Re: **East Windsor Solar Two, LLC and VCP, LLC d/b/a Verogy – Petition for a Declaratory Ruling that a Certificate of Environmental Compatibility and Public Need is not Required for the Construction, Operation and Maintenance of a 4.0 MWAC Ground-Mounted Solar Photovoltaic Project at 31 Thrall Road, East Windsor, Connecticut**

Pre-Hearing Interrogatory Responses

IN RE: :
 :
 :
 A PETITION FOR A DECLARATORY RULING : PETITION NO. 1572
 THAT A CERTIFICATE OF ENVIRONMENTAL :
 COMPATIBILITY AND PUBLIC NEED IS NOT :
 REQUIRED FOR THE CONSTRUCTION, :
 OPERATION AND MAINTENANCE OF A 4.0 :
 MW AC SOLAR PHOTOVOLTAIC PROJECT AT :
 31 THRALL ROAD, EAST WINDSOR, :
 CONNECTICUT : JULY 18, 2023

**RESPONSES OF EAST WINDSOR SOLAR TWO, LLC AND VCP, LLC
D/B/A VEROGY TO CONNECTICUT SITING COUNCIL INTERROGATORIES**

SHEET NUMBER:
OP-2

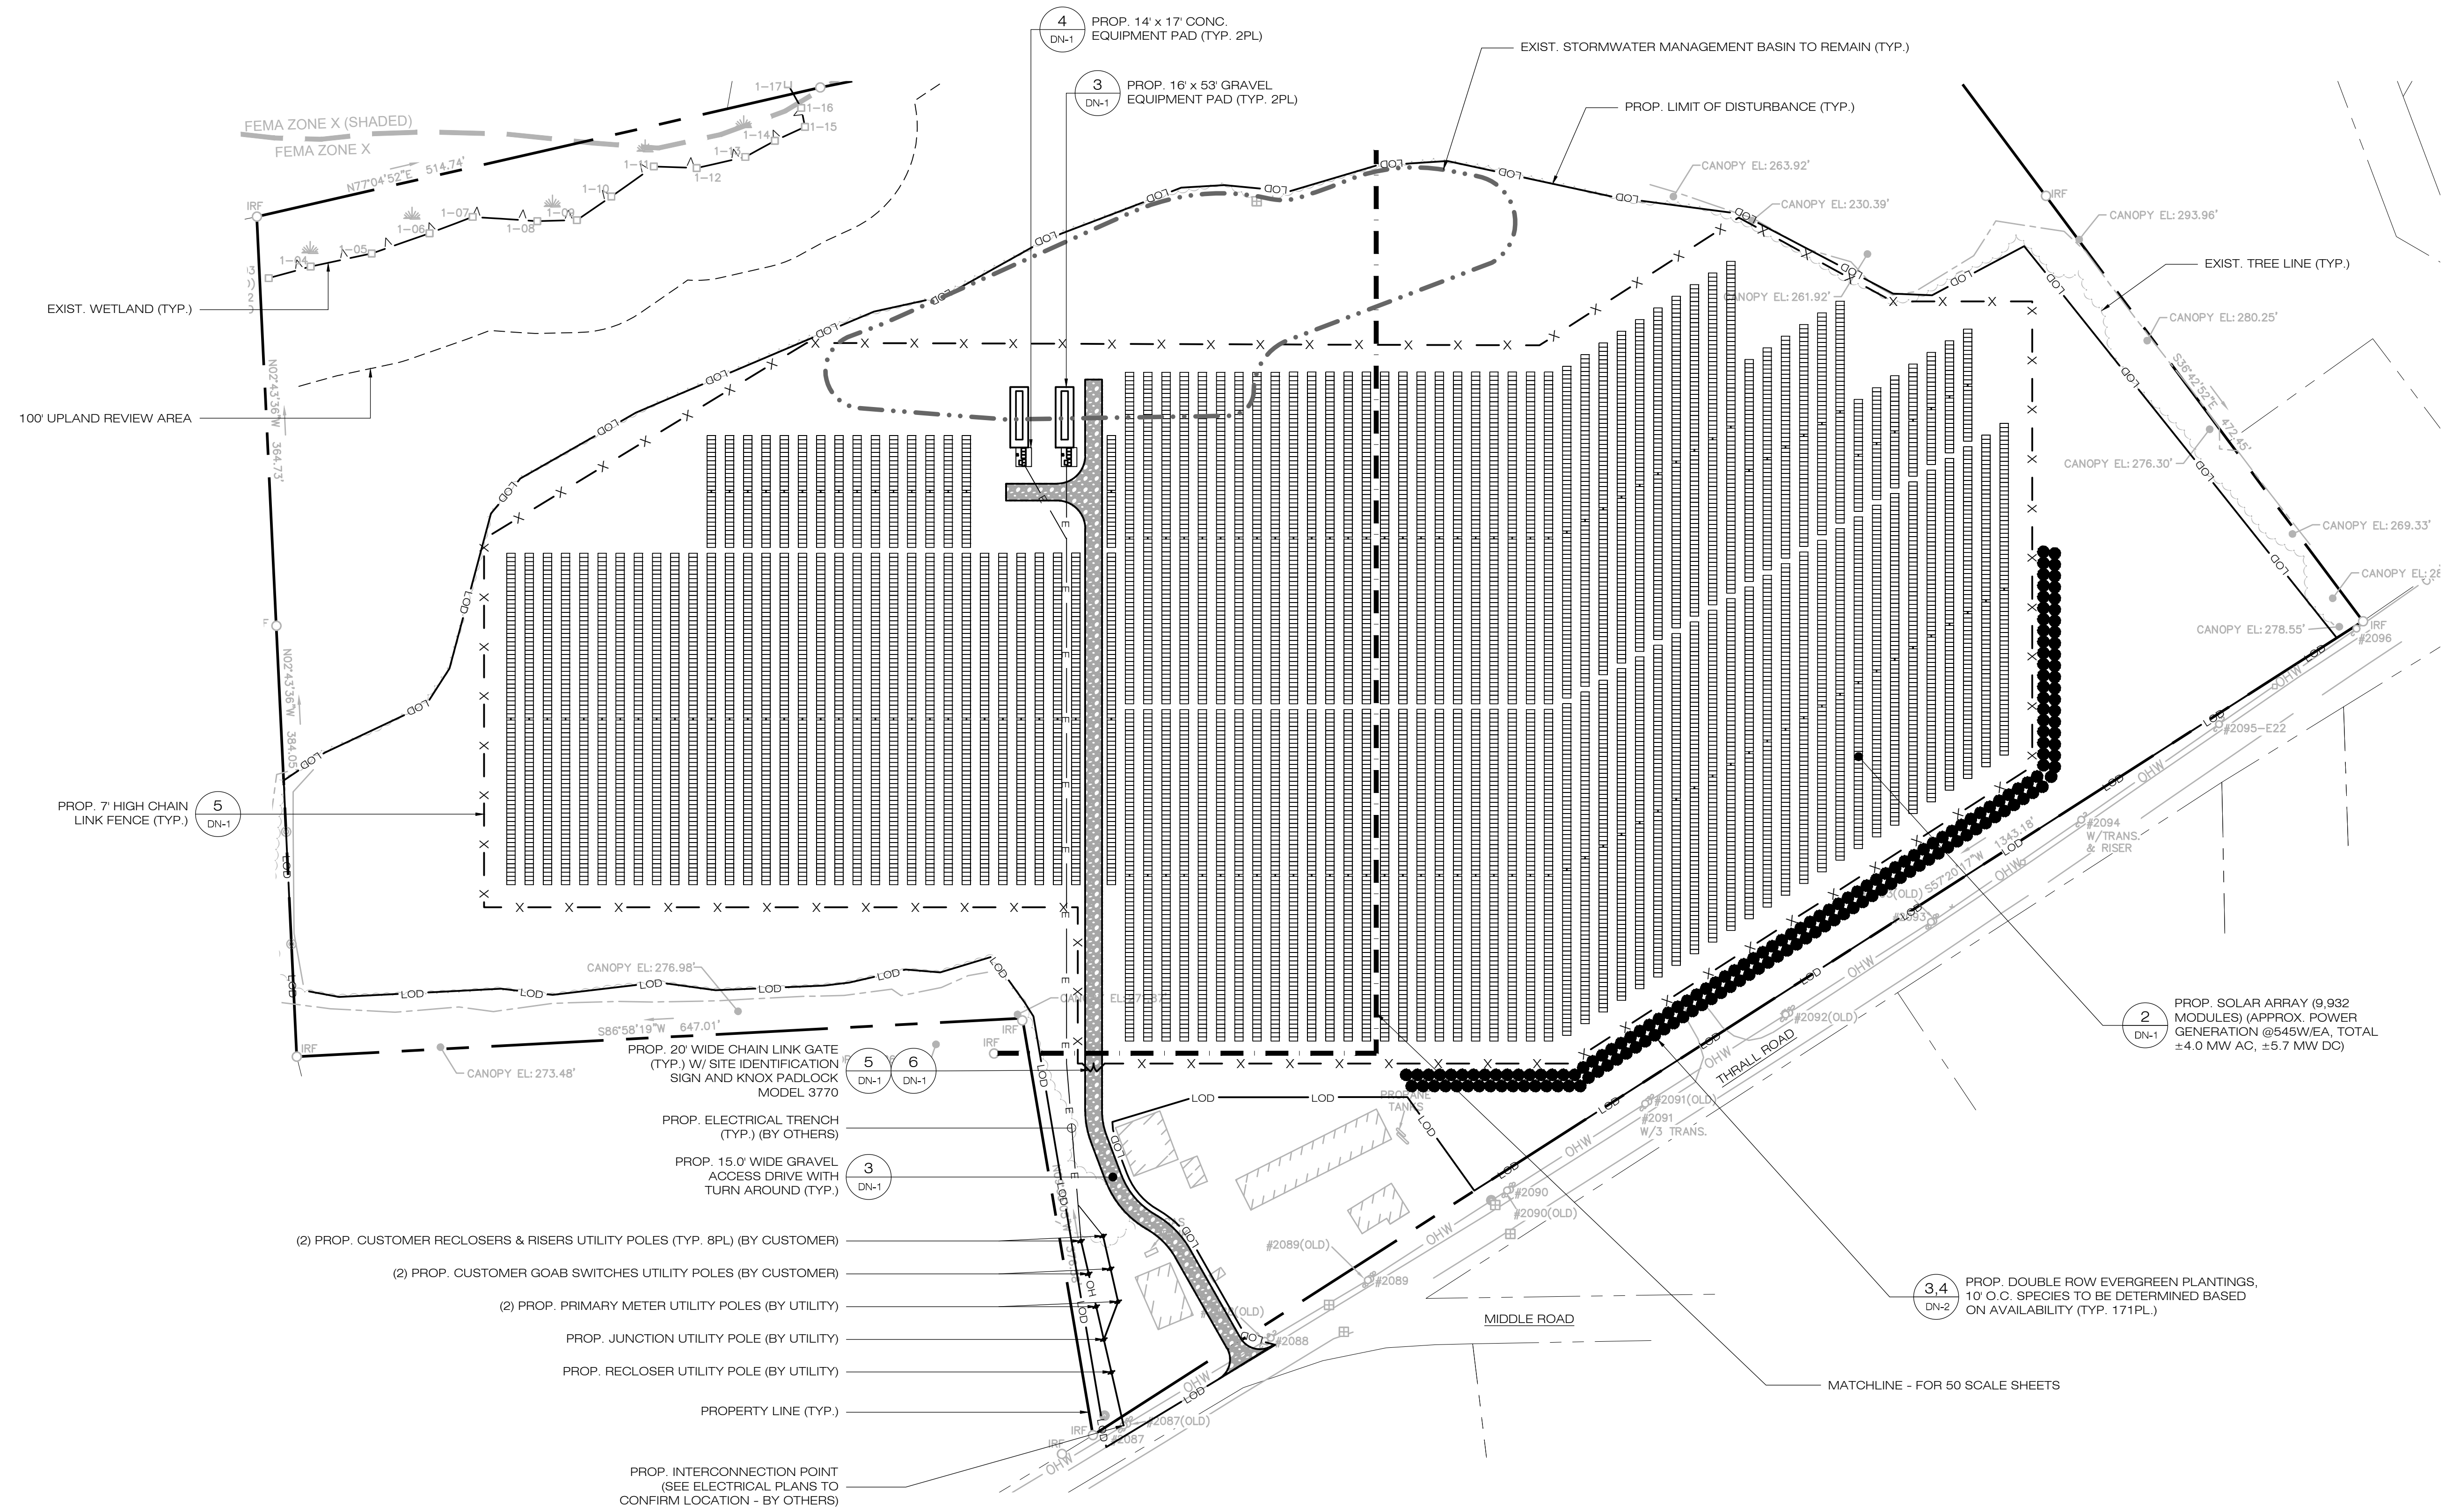
Referencing page 8 and Partial Site Plan OP-2, the proposed poles are a single utility recloser pole; junction pole; two utility primary meter poles; two customer disconnect switch poles; and two customer recloser poles. Identify each of these poles on Partial Site Plan OP-2. What equipment is mounted on each pole? Can the number of poles be reduced by consolidating equipment?

Attachment 2 includes a revised Partial Site Plan OP-2, which identifies which equipment each utility pole contains. Because the EWST Facility has two separate SCEF contracts, the Petitioner is required by the Eversource and the SCEF program rules to maintain separate meters. This in turn necessitates the installation of separate disconnect switches and customer installed reclosers. Therefore, the equipment cannot be consolidated.

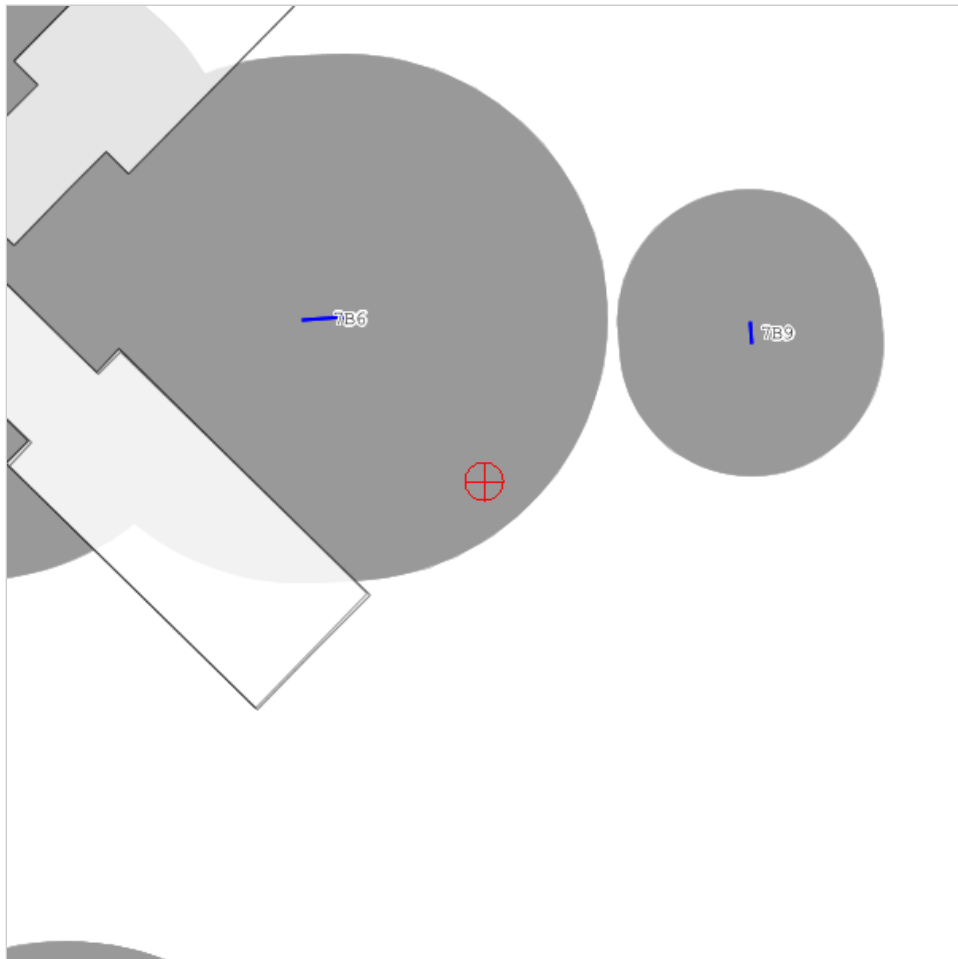
Would EWST be required to file a Federal Aviation Administration (FAA) Form 7460 for temporary equipment if a small crane, excavator, or other tall equipment is used at the site during construction?

No. *See* the Notice Criteria Tool for a Temporary Crane included in Attachment 3.

PHOTO LOG (GROUND)

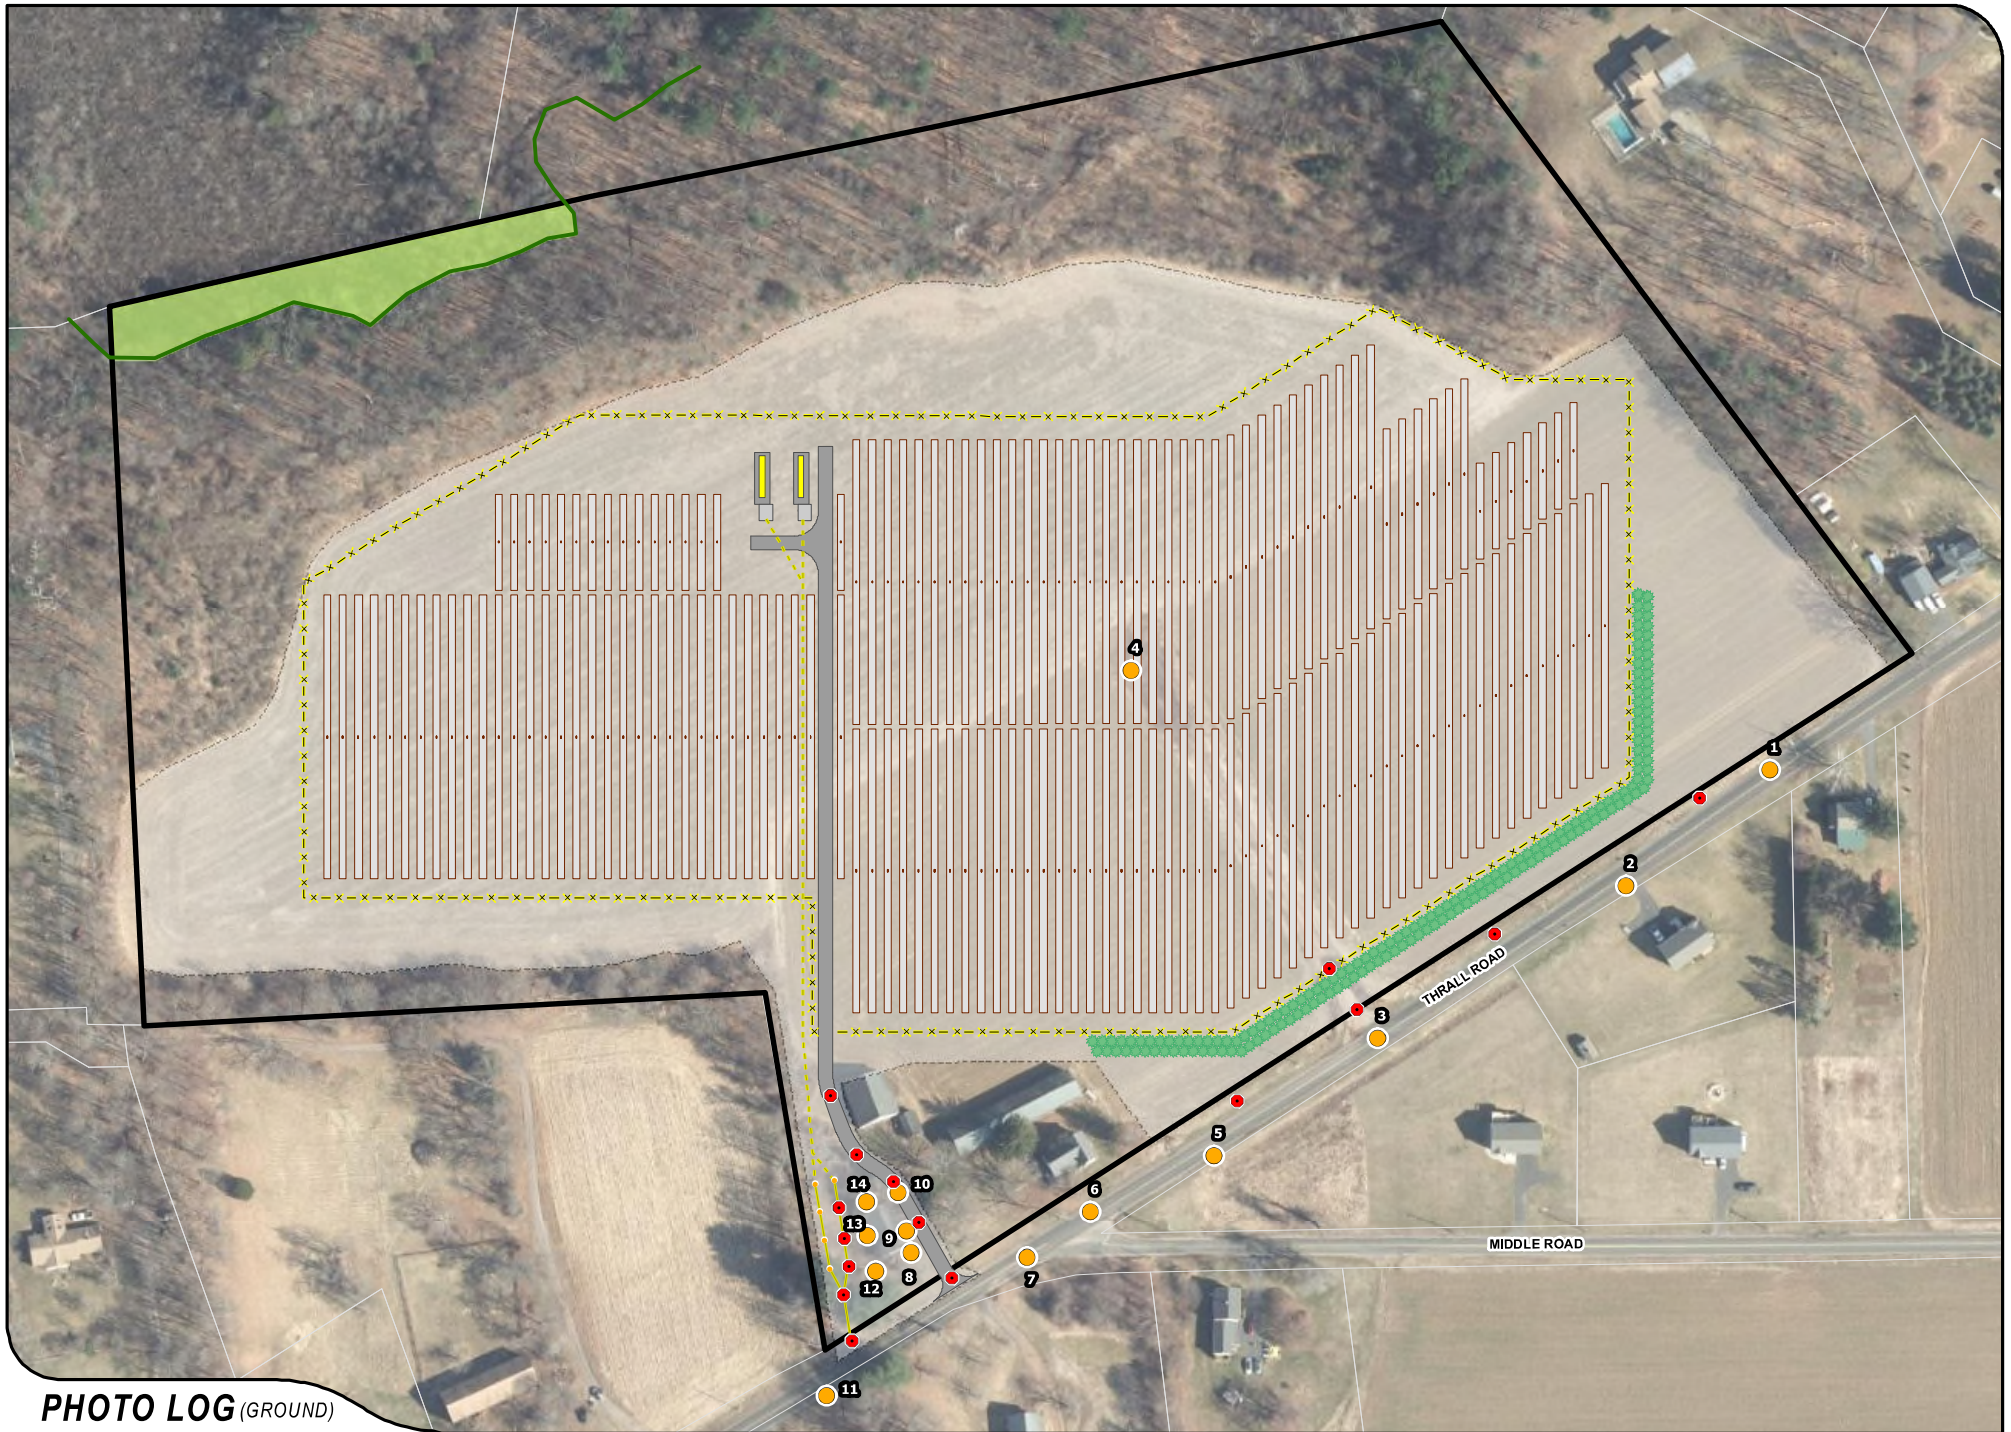
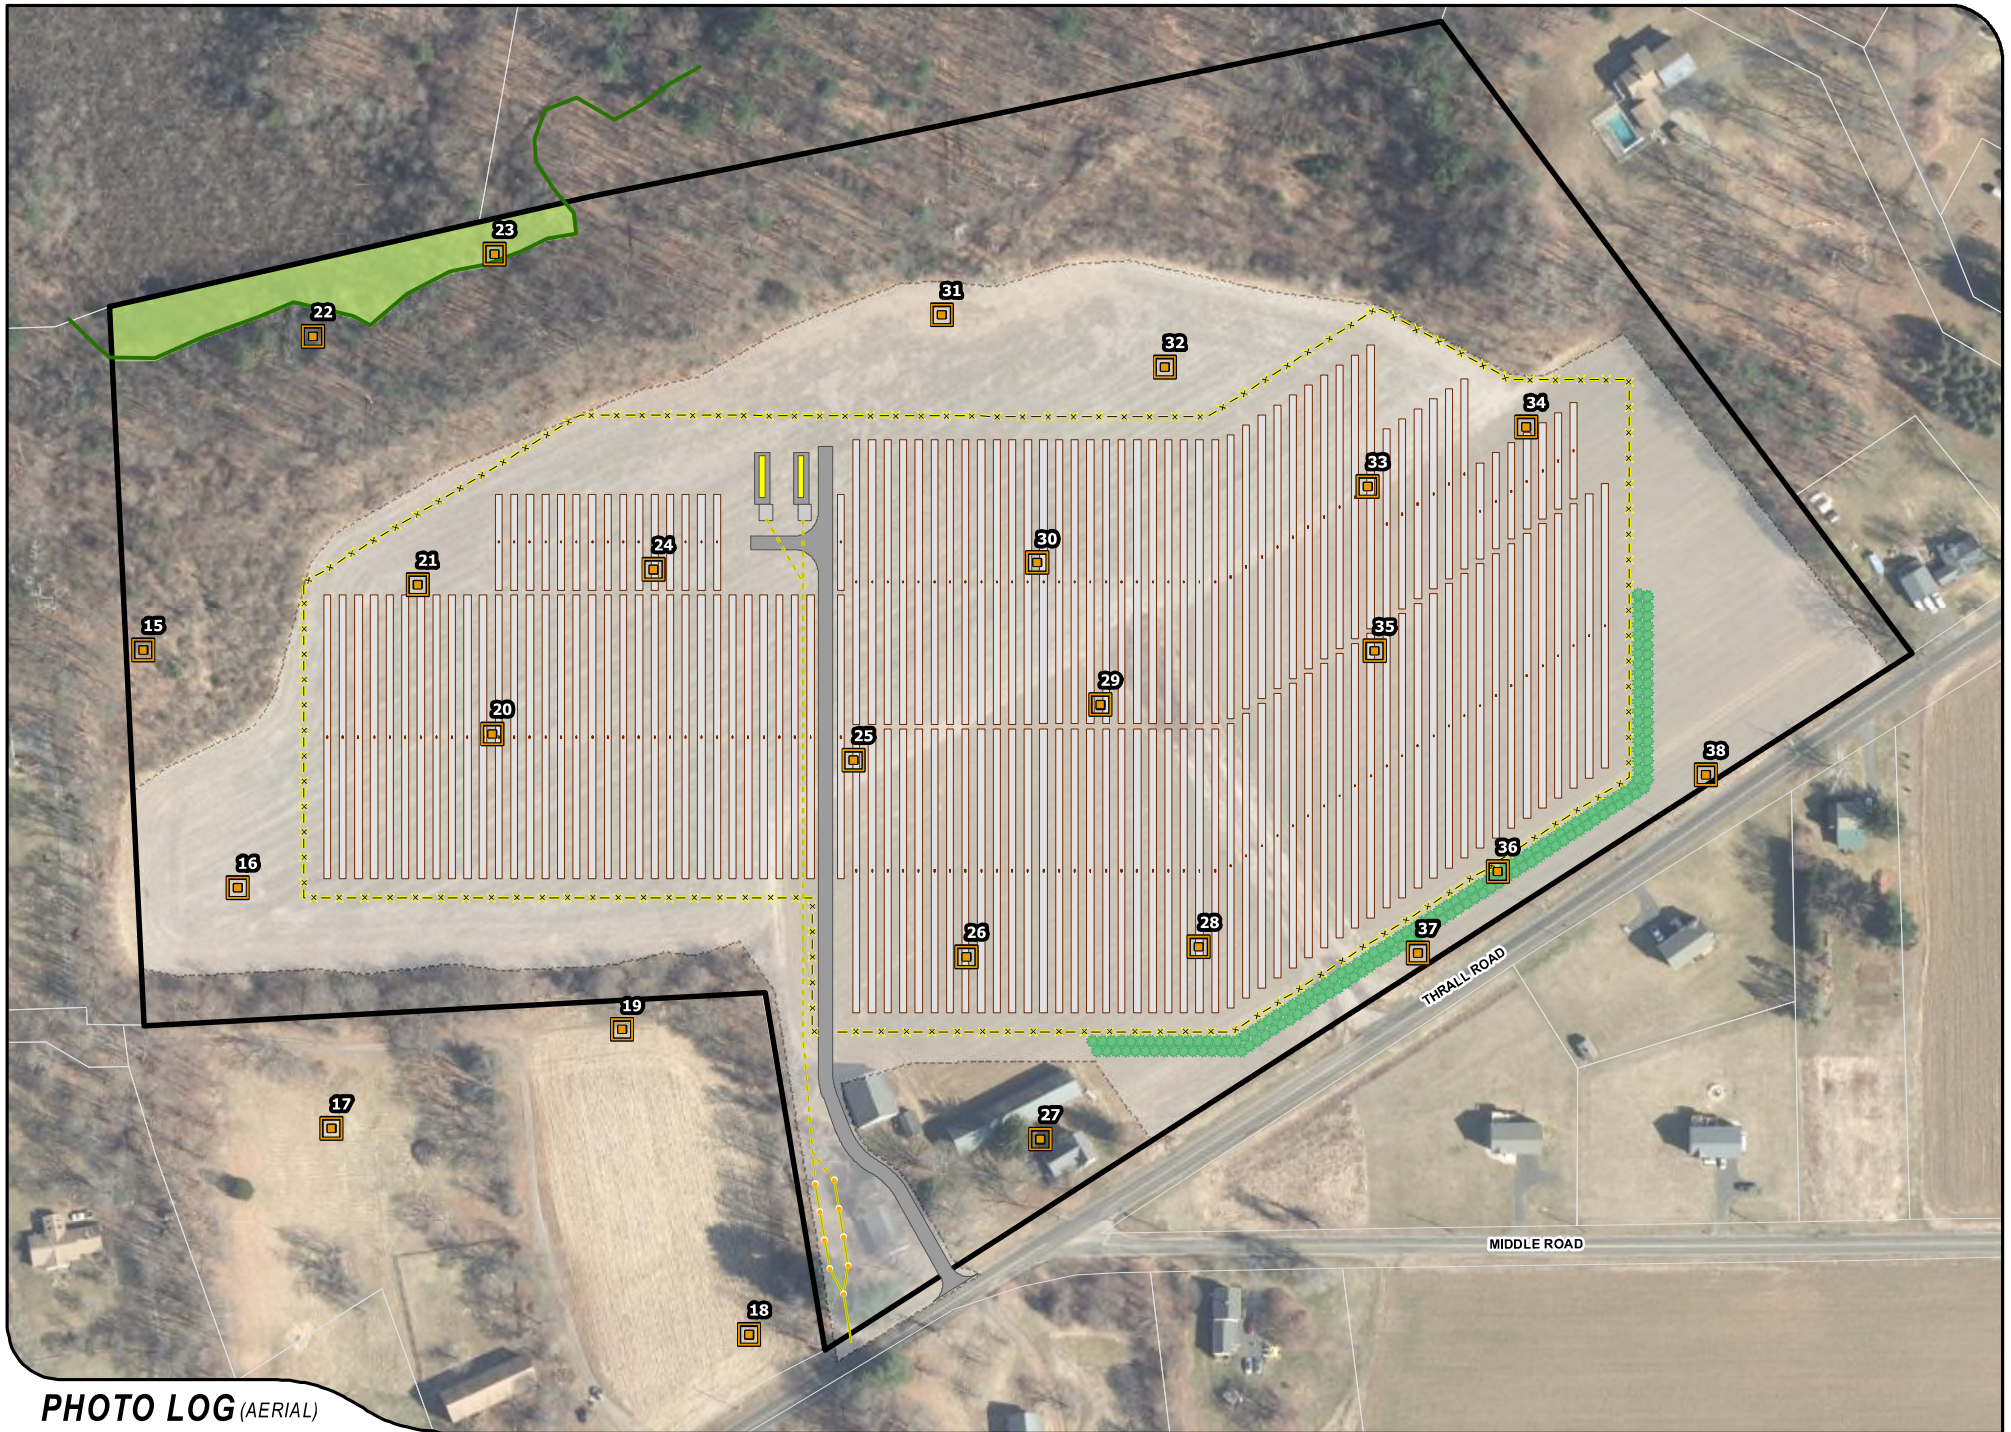
Please submit photographic site documentation with notations linked to the site plans or a detailed aerial image that identify locations of site-specific and representative site features. The submission should include photographs of the site from public road(s) or publicly accessible area(s) as well as Site-specific locations depicting site features including, but not necessarily limited to, the following locations as applicable:

See Attachment 4.
